**CITY OF MADISON
ZONING BOARD OF APPEALS
VARIANCE APPLICATION**

Address of Subject Property: 1725 Fritz Ave.

CERTIFIED SURVEY MAP

RE: File No. LD 1307 – Certified Survey Map – 1725 Fritz Avenue (MIG Homes, Inc.)

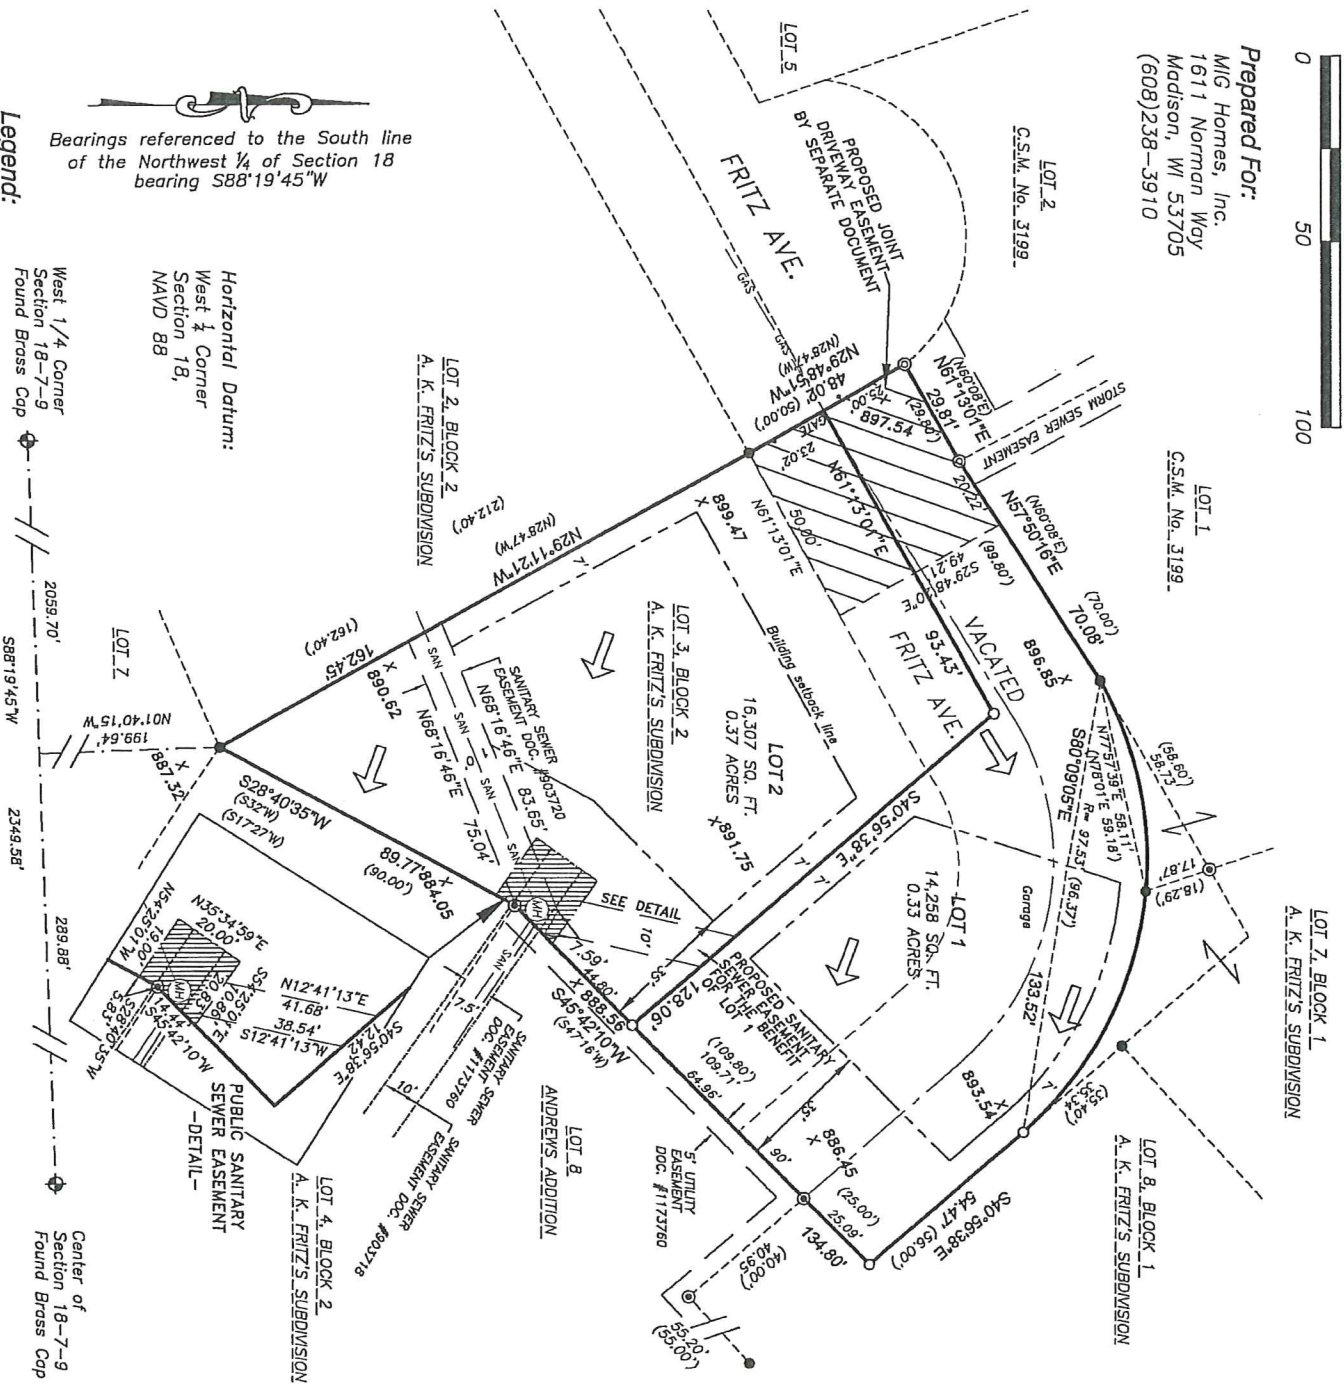
1. Reconcile the discrepancies between the curve data shown on the map and information contained in the legal description.
2. Reconcile the omission of interior lot dimensions for Lots 1 and 2.

3. Map the existing sanitary sewer based on field measured locations of all sanitary structures located on the site as well as a minimum of one additional structure upstream and downstream from the structure located on this CSM.

4. Revise the CSM to dedicate a public sanitary sewer easement, 10-foot by 10-foot, centered over the existing public sanitary sewer structure.
5. Map, dimension and reference the existing Register of Deeds document numbers (Document Nos. 903718, 903720 and 1173760) for all existing public sanitary sewer easements contained within, and adjacent to, this proposed CSM.

6. Map all existing dwelling structures located within the boundary of this proposed CSM.
7. It appears there may need to be a shared ingress and egress created for this proposed lots. Provide reference to this on the CSM if created and recorded pre-CSM by separate document.

8. Specify a horizontal datum basis of bearings on the CSM. If assumed, state as such.
9. Add the following note to the CSM: "At the time these lots develop, stormwater infiltration/ detention shall be required, limiting downstream discharge to the current (undeveloped) rate and volume."

24. The following CSM revisions shall be made:
 - a.) Include a brief legal header on each sheet of the CSM.
 - b.) Update the sheet numbers to correctly represent what exists.

- c.) Combine #3 and #4 from Part "A" of the title report and include as a note on Sheet 3 of the CSM.
 - d.) Remove the duplicated notes from Sheet 4.

- e.) Update the label and description of the sanitary sewer easement to show what is reported in title and add the Document No. for said easement.
 - f.) Create and record, or show as being dedicated in the proposed CSM, easements for utility and drainage rights of way when the utility or drainage physically exists, but no document for it exists in record title.
